From: Steven Burk [sody1@msn.com]
Sent: Monday, July 05, 2010 12:44 AM
To: Edl, Michele
Subject: FW: additional information request/ Pond and its Wier control valve 2 Of 2
Attachments: 100_0983.JPG; 100_0990.JPG; henrys lake lodge .jpg

The narrative in the field examination report for your Permit 21-7566 is very brief and doesn't contain all the information I like to see. That makes licensing more difficult but I believe that I will be able to bring this permit up to license status. I do need clarification on a few points.

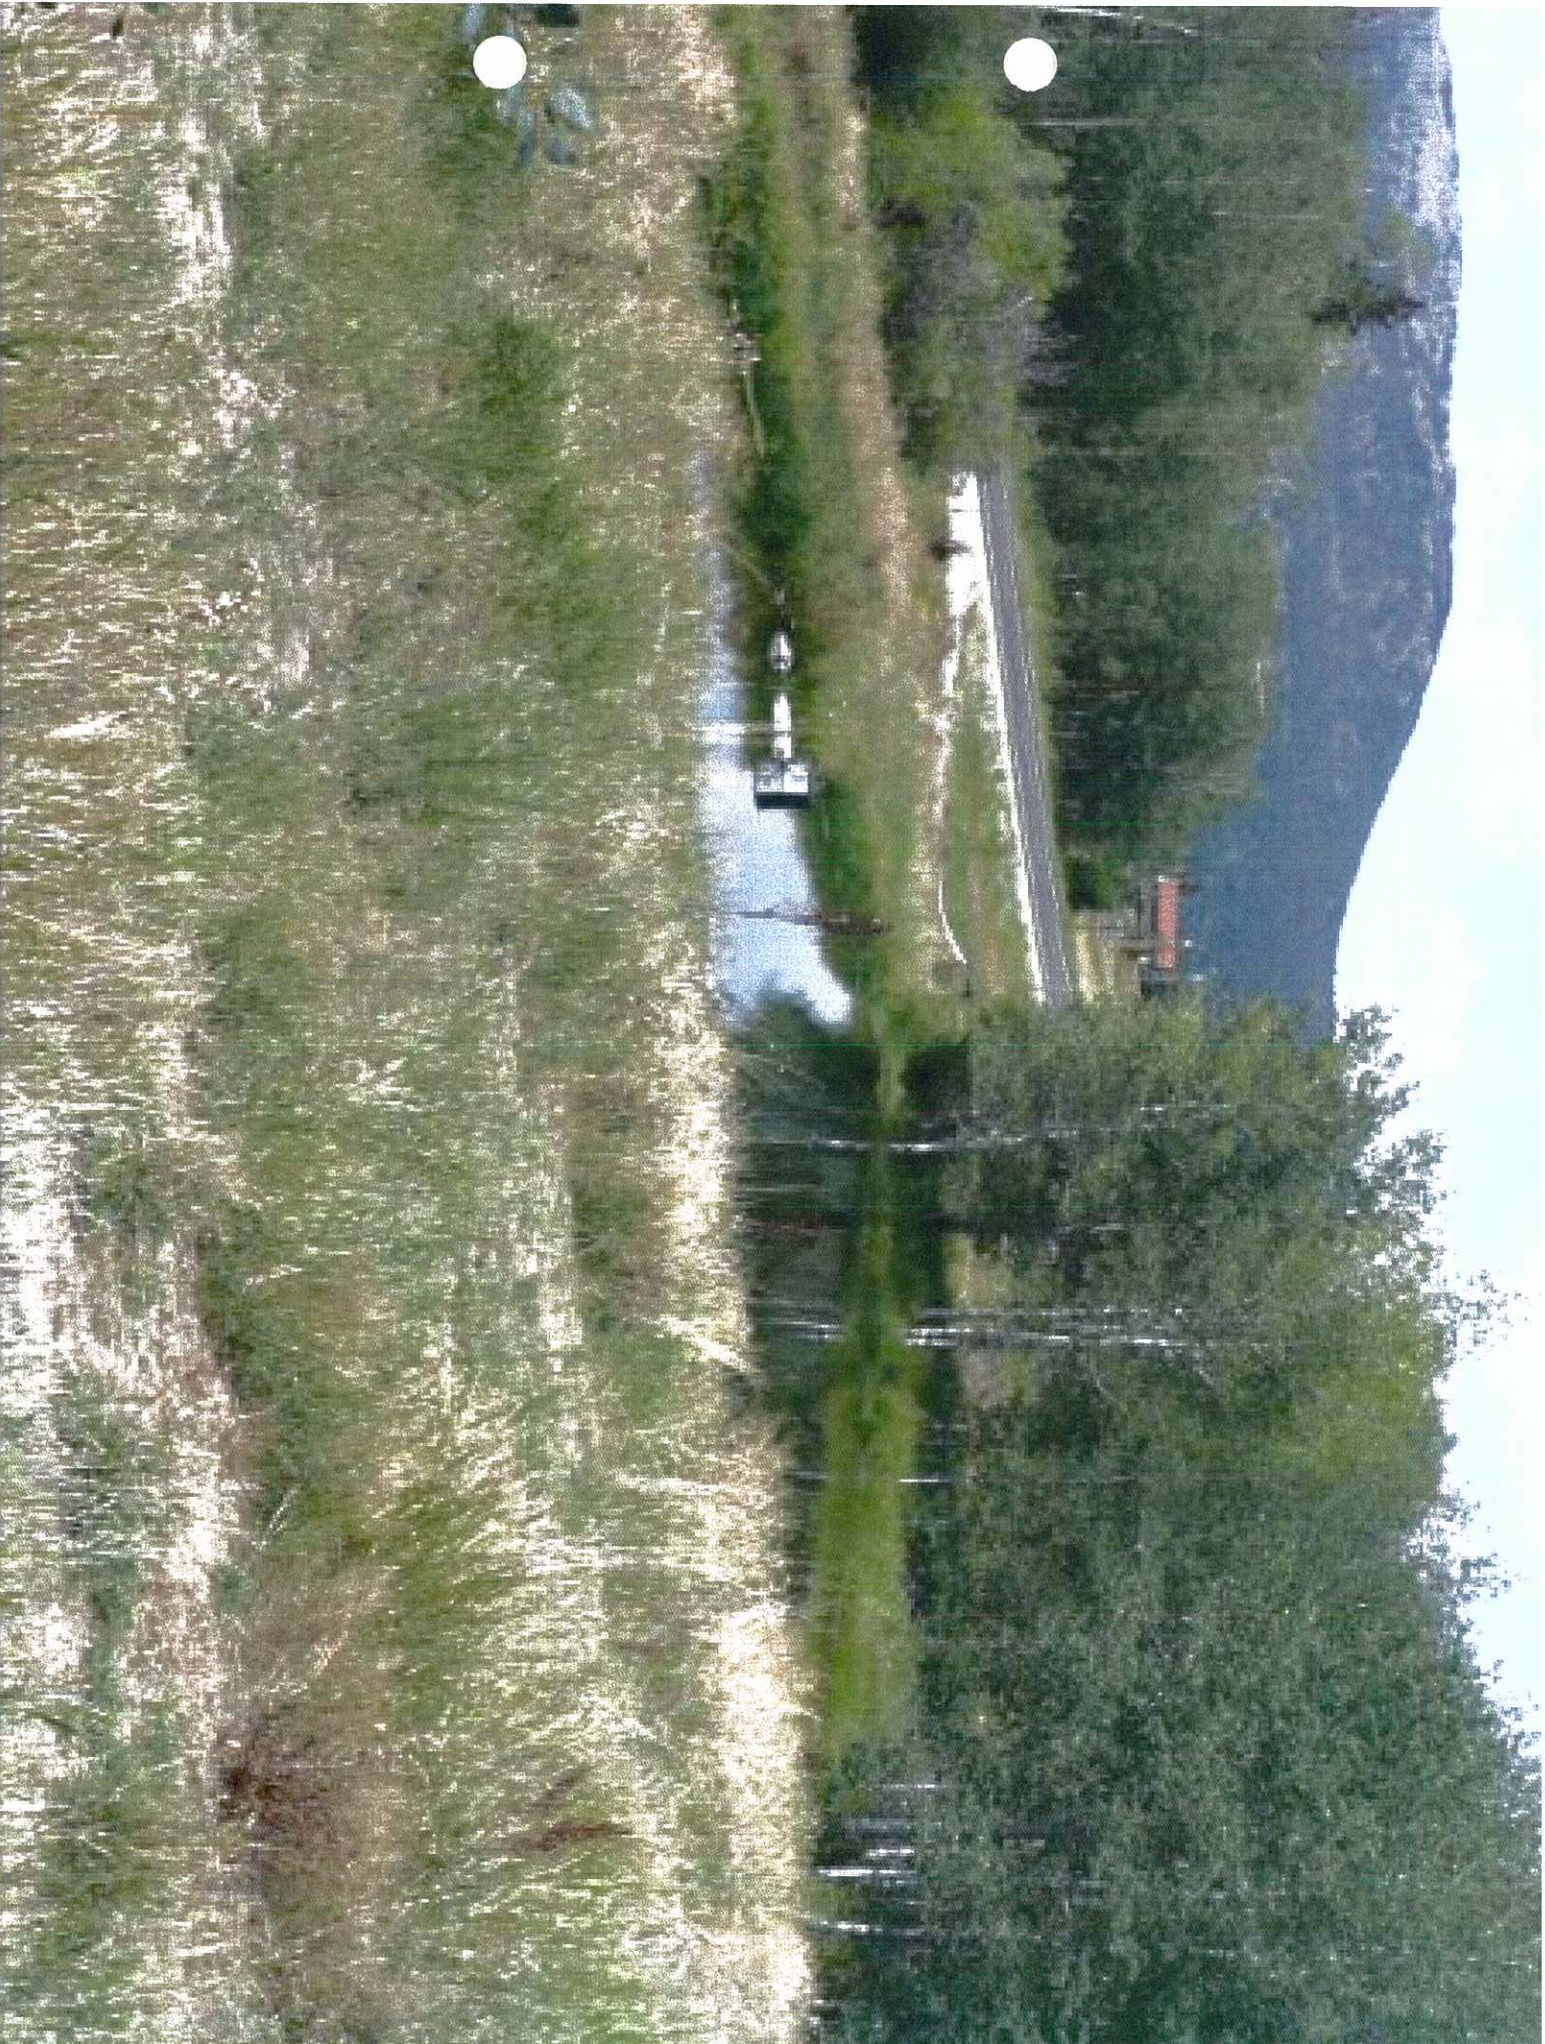
This is the second set of pictures of the pond with its separate three unnamed Springs. As you can see from the location of the pond, there is a 250 foot separation from the Lodge and the pond. The pond is fed its water from an entirely different set of springs. The Hatchery Stream originating from the spring box runs down along the east side of the lodge building, while the three unnamed Springs feeding the pond all come from the west side of not only the lodge itself, but also from the westside of the pond. These two spring systems are separated by approximately, plus or minus, 500 feet, and never flow into each other. If you will look at the aerial photo, which I sent to you in an earlier e-mail, and have included again here, I think you can identify the spring box located up hill and to the right, or East side of the lodge, and also the three unnamed Springs that feed the pond, which all originate far to the west side of the lodge building which feeds the large stand of trees uphill from the pond.
